TRANSBAY JOINT POWERS AUTHORITY

REQUEST FOR PROPOSALS No. 18-02 TWO-WAY RADIO SYSTEM

QUESTIONS & ANSWERS: Set No. 2

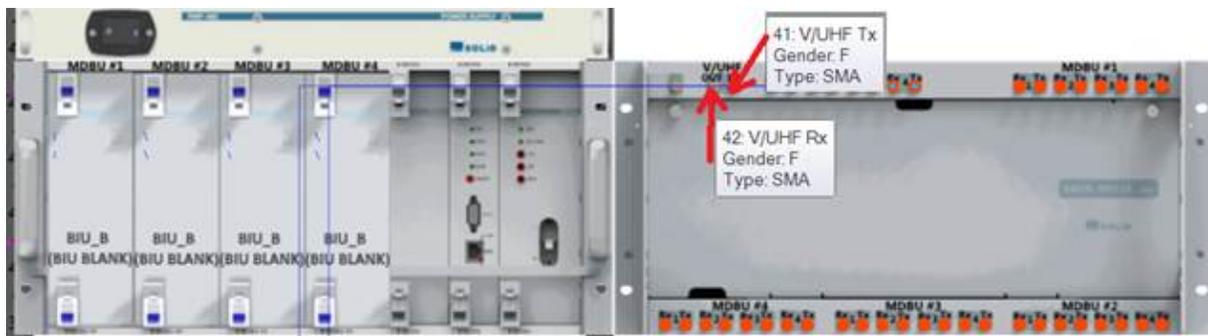
7. ***Q: RFP 18-02 QA question 3 response states that the target radio coverage is 95% for the DAS. If the DAS or BDA system don't provide 95% coverage how will it be remedied?***

A: Boingo is obligated to provide 95% coverage throughout the transit center. Any areas found to have less than 95% coverage should be brought to the TJPA's attention and will be addressed with Boingo.

Part properties

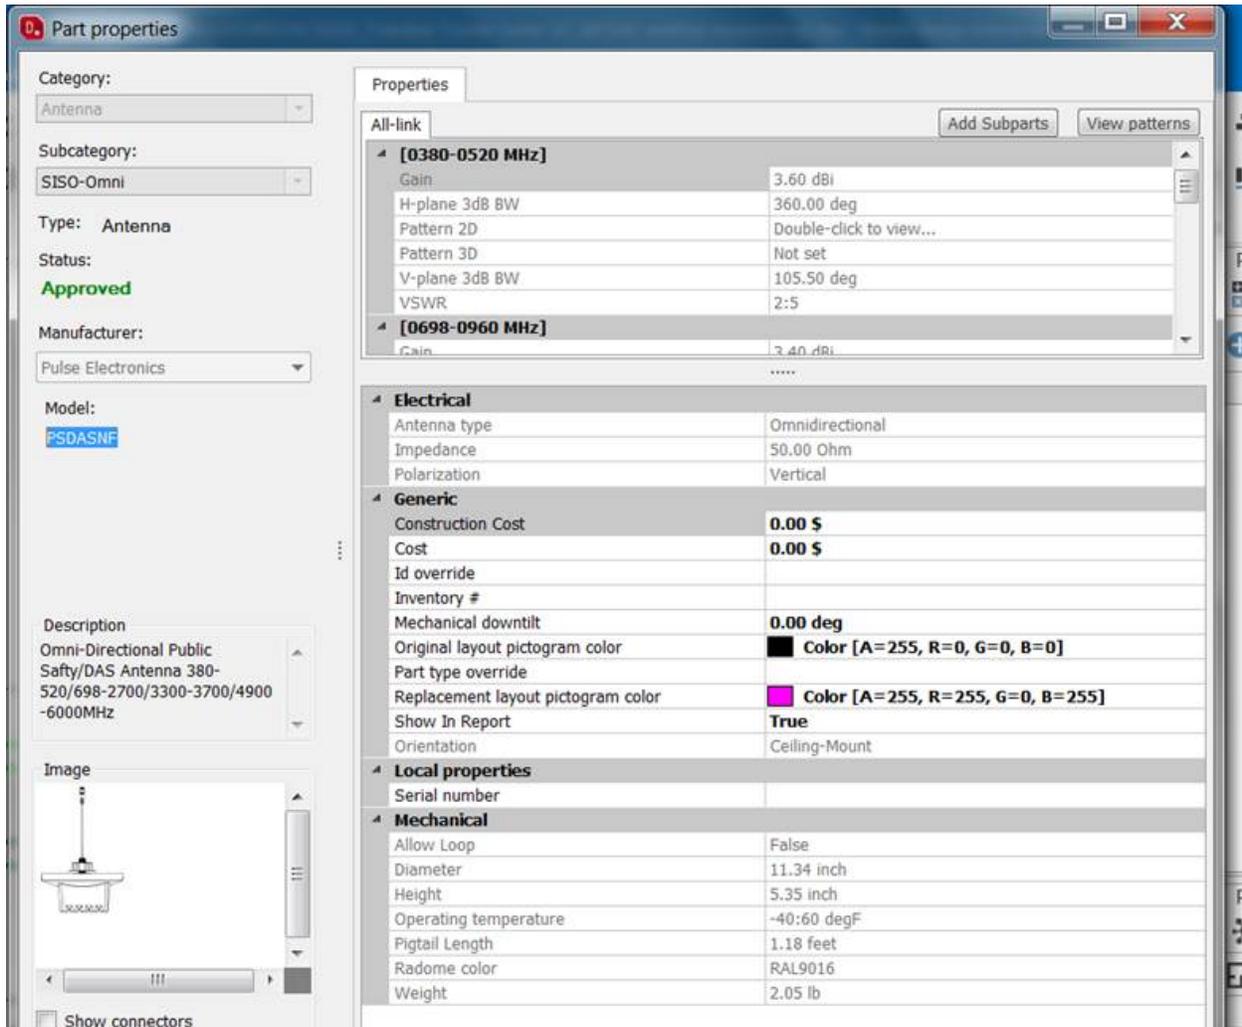
9. ***Q: Boingo will certify that the DAS provides 95% coverage and Responders to RFP 18-02 are only providing hardware to link to DAS, correct?***

A: Yes. For clarification, Boingo will provide the 95% coverage for the downlink only. The uplink coverage depends on the radio handset power. Refer to the following diagrams for additional information.

UHF BIU ports:

BIU power range:
